RE: Project Name: PRC2023- 00010 DevCo Arvada 64 Rezone and Minor Subdivision

Thank you for the comments on *May 3, 2023* for the above-mentioned project. In an effort to address your comments concisely and simplify your review of the Rezone and Minor Subdivision, we have summarized your comments and our responses below.

DEVELOPMENT TEAM REVIEW COMMENTS

DRAWING NAME
OVERALL SITE PLAN

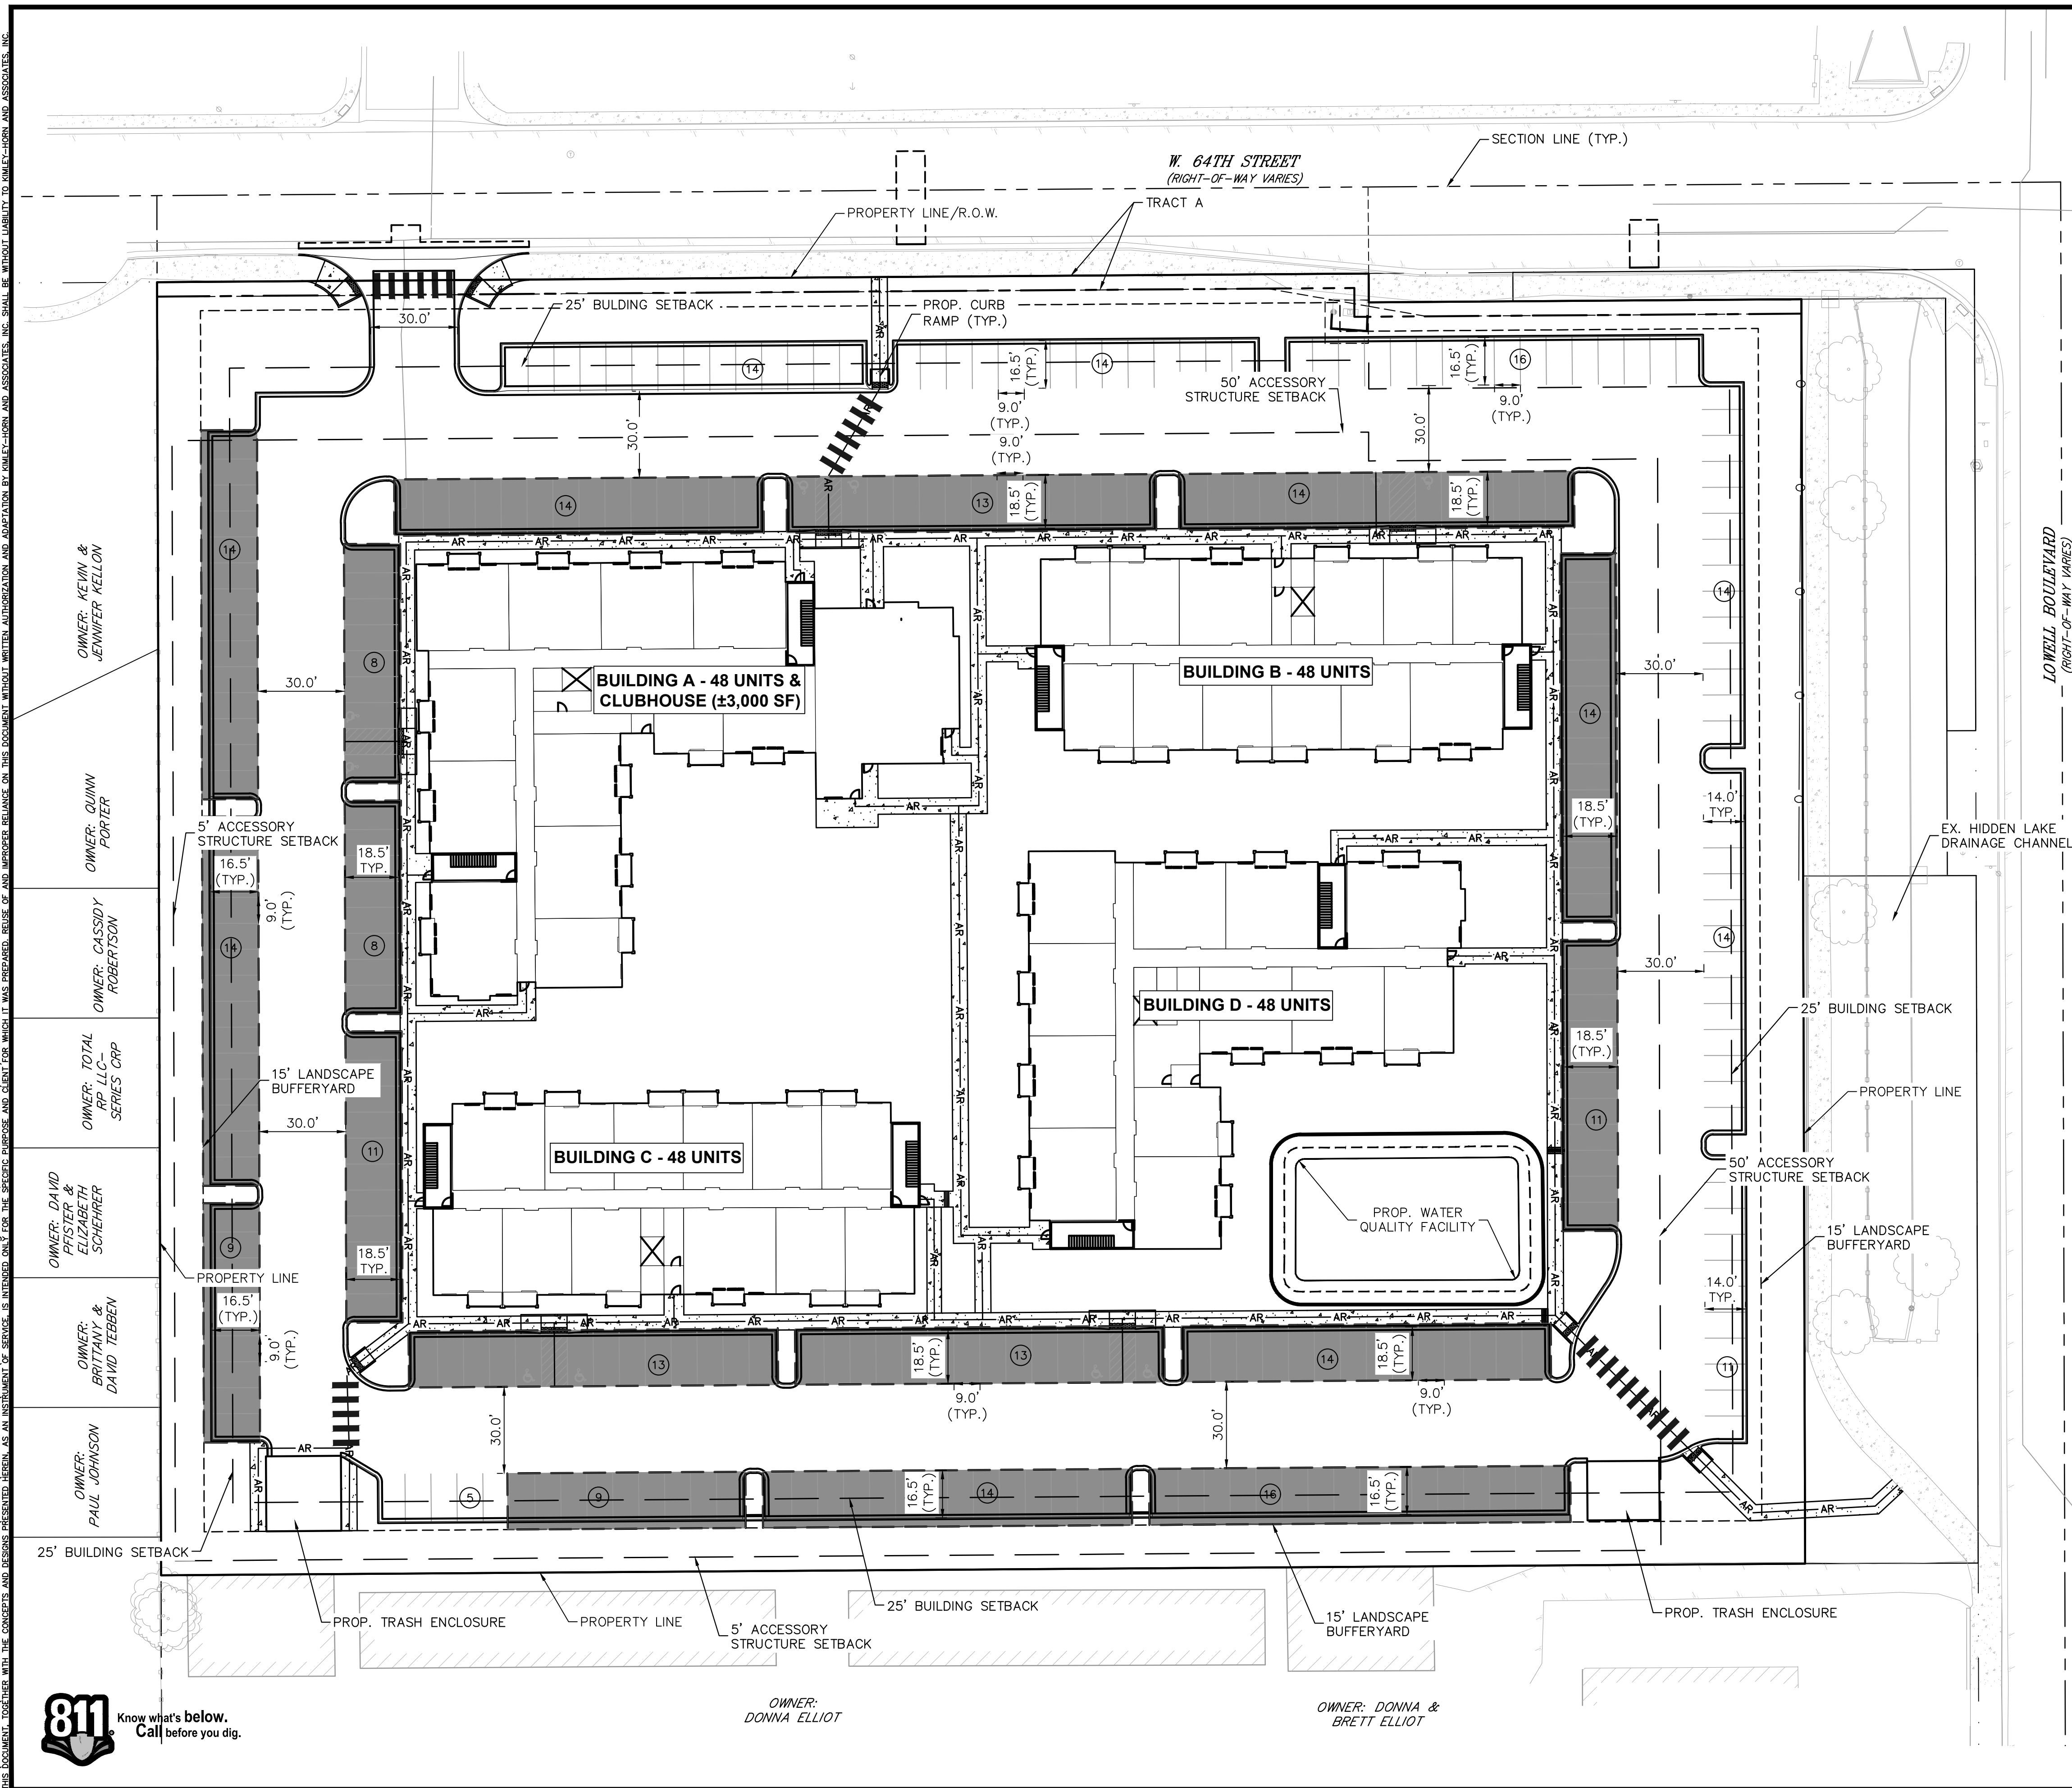
ENV11. The applicant may want to consider crosswalk(s) where pedestrian access and/or sidewalk crosses internal site drive lanes, as these pedestrian crossings may not be easily visible to drivers if they are not at a street intersection. The simplest crossing design would be to post signs and provide striping on the pavement. A safer design alternative would be to provide a raised pedestrian crossing, with striping and a contrasting color, to clearly delineate the crossing. The raised crossing will provide the added benefit of slowing traffic and improving driver awareness of the crossing.

ENG11: The site plan only shows one vehicular access point for the development. The applicant should confirm with the Fire Marshal/District if this will be acceptable.

- ❖ Note only at this time. Additional information needed on structures.
- *Response: Acknowledged. Fire apparatus roads are proposed to be 26' wide.*
- Fire apparatus access roads shall be within 150' of all ground level exterior portions of the building.

- ❖ Note only at this time. Additional information needed on structures.
- *Response: Per further discussions with Whitney Even, since the buildings will be installed with a fire sprinkler system in accordance with NFPA 13R system, a 225-foot length from fire access road to all ground level exterior portions of a building will be acceptable. Please see site plan.*

- *Response: The site plan depicts painted cross walks at pedestrian crossings. Please site plan.*

- *Response: The Applicant has reviewed this proposal with the Adams County Fire Rescue and it has been determined that provided that the unit count does not exceed 200, that a second point of access is not required.*
